Technical Commercial Information

Number **1VCD850134R0001**

Division: Power Products
Issued by: AP-PM/mc
Date: 16th September 2015
Title: **Update of Primary Distribution Circuit-Breaker**

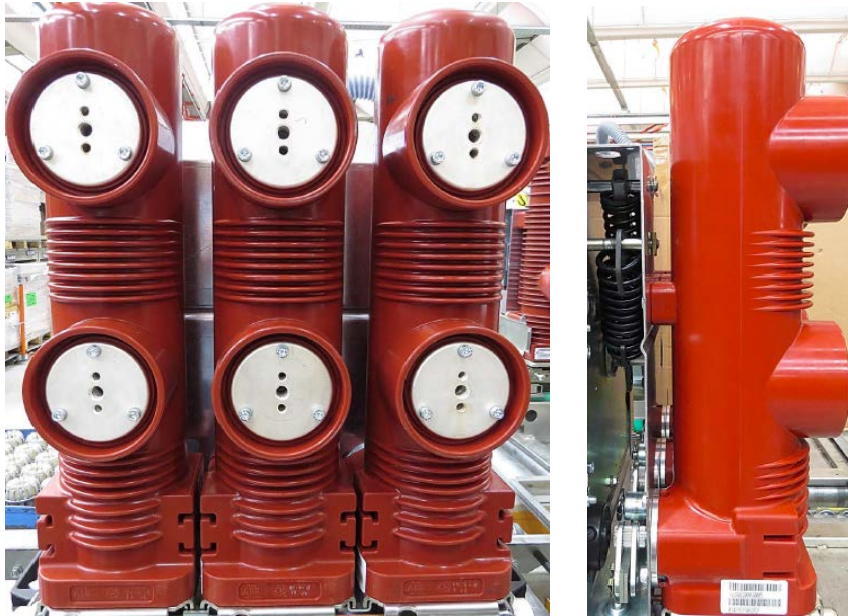
The shape of cylinder in epoxy resin and the terminals have been improved. Particularly the upper terminal is now in rear side as the lower terminal; moreover respect to previous freestanding types there are no “L shape” connection so the bars/cables can be connected to terminal directly and easily. Please see next pictures.

Withdrawable types are fully interchangeable with previous types.

Freestanding types keep the same pole centre distance, the same position of the terminals, more/less same overall dimensions, then, even though not fully interchangeable, freestanding types can be easily adapted by OEMs into their interchangeable withdrawable versions.
